The bridge design is a straight trestle, like the sewer bridge crossing the cut just next to Tower Road.

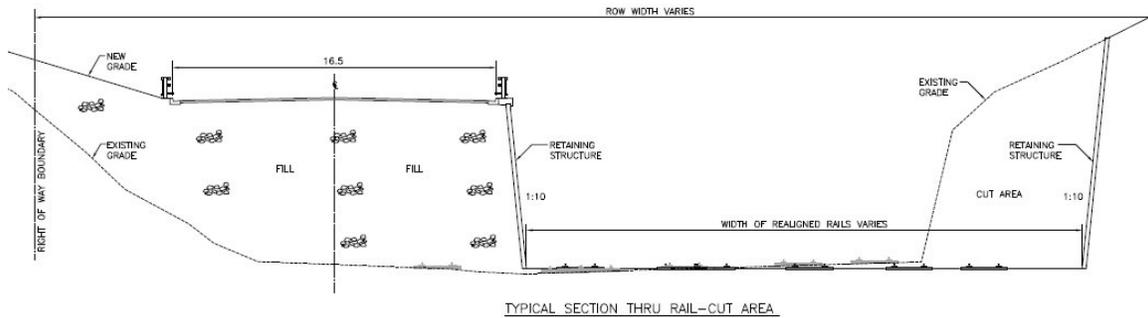
There are two proposed transportation projects that would cross the alignment of this bridge and make it difficult if not impossible to build it. The first is the Robie Street Connection as laid out in the Final Report, Railway Cut Investigation Study, February 2004.

The above shows one of three possible alignments for a truck route rising from the bottom of the rail cut up a ramp to the south end of Robie Street. The alignment of the Greenway and its pedestrian bridge is overlain.

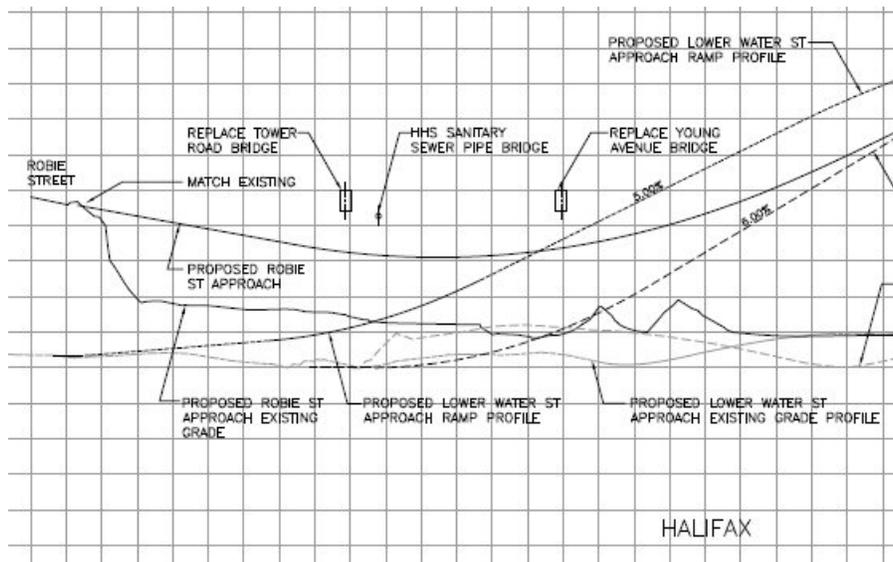
The figure below shows that the cross section of the rail cut would be altered and the roadbed elevated.

The proposed Robie Street approach would match the existing grade at the top of the cut.

This combination of alterations to the existing rail cut would seem to eliminate any possibility of aligning a straight design pedestrian bridge between The Oaks property and Pine Hill Drive.
